SERVICE BULLETIN

Service Bulletin No.: DAC1-71-01 Rev 1

Title: Cowling Thermal Protection Shielding

Figure 1

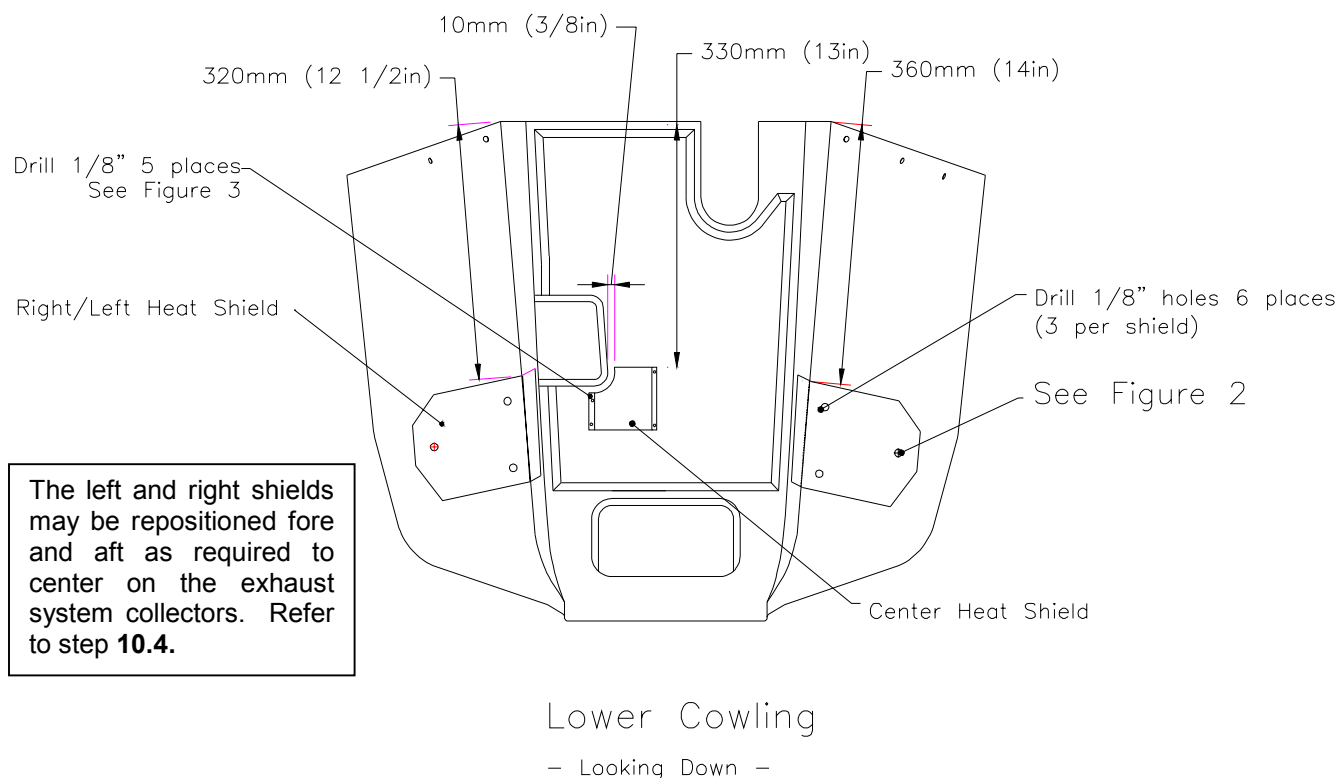
- 10.1** Remove cowlings from aircraft.
- 10.2** Inspect the exhaust system for leakage. Repair components as required.
- 10.3** Place left and right side shields on the inside of the lower cowling in the locations shown in Figure 1. Bend the shields as required to follow the profile of the cowling.

- 10.5** Position the center lower heat shield as shown in figure 1. Mark the 5 hole locations.
- 10.6** Drill 1/8" holes in the marked locations (11 holes).

Figure 2

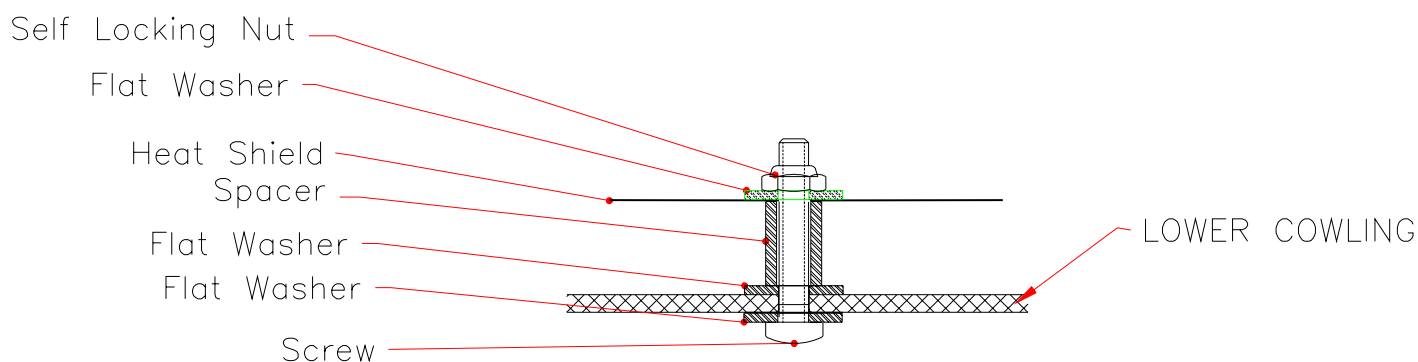
- 10.7** Install the left and right heat shields with the supplied hardware following the instructions in Figure 2.
- 10.8** Install the center heat shield with Rivets as shown in Figure 3.
